# LiDAR Quality Assessment Report

## AZ\_LowerColoradoRiver\_2018\_B18

Project: AZ\_LowerColoradoRiver\_2018\_B18

This report is for Block 1 of the project.

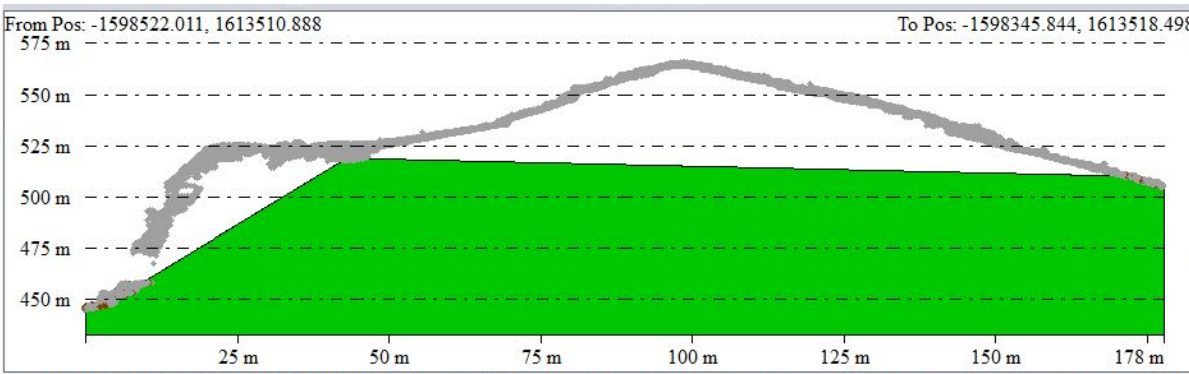
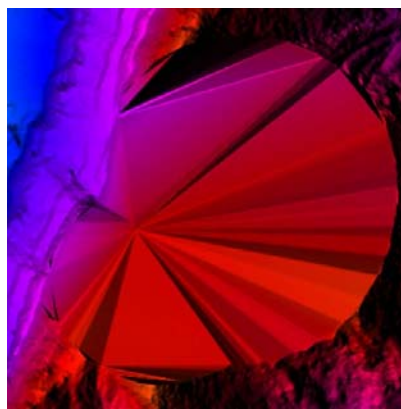
**3 bridges need to be removed:**

10 instances where ground points were misclassified:

Corrected (4/24/2019).

Corrected (4/24/2019).

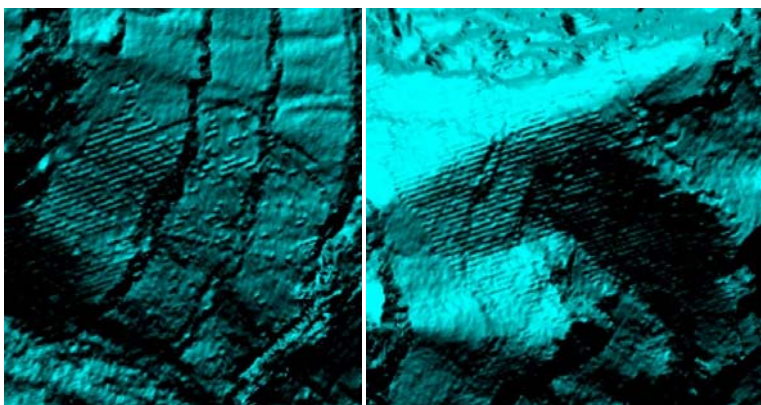
3 instances of undulation:

Corrected (4/24/2019).

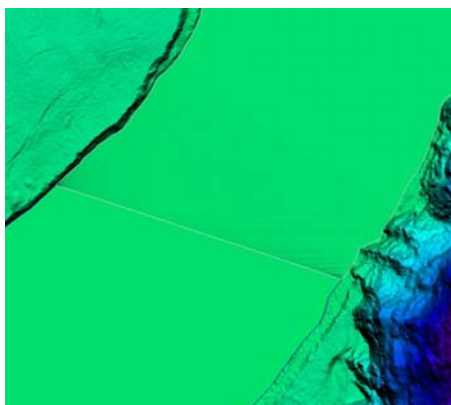
**1 feature requires breakline enforcement:**

Corrected (4/24/2019).

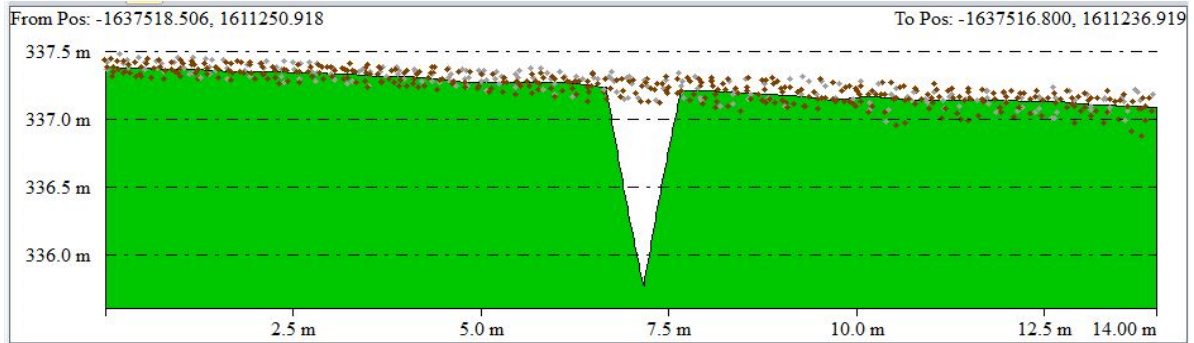
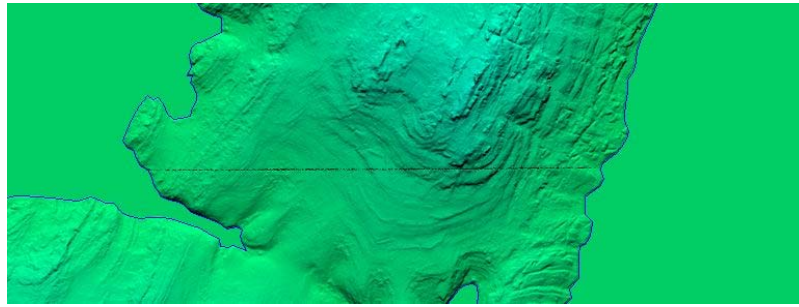
**7 unknown anomalies:**

Corrected (4/24/2019).

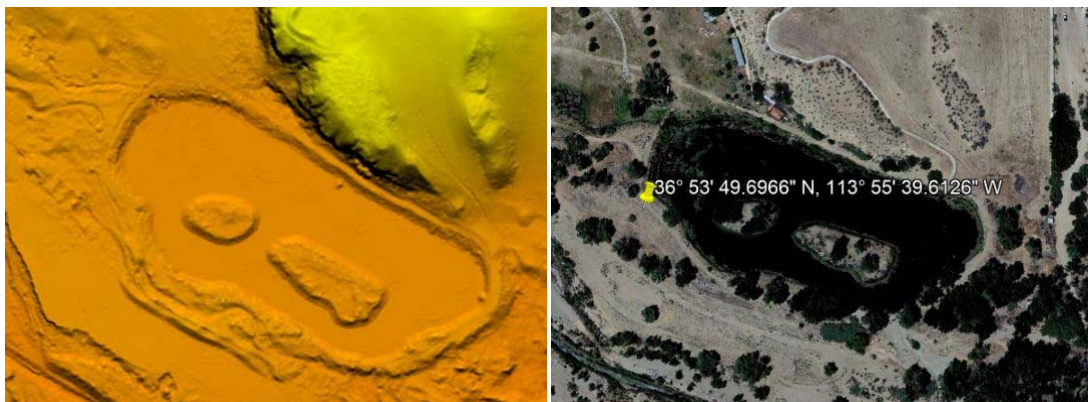
**3 instances of undulation/corrowing**

Corrected (4/24/2019).
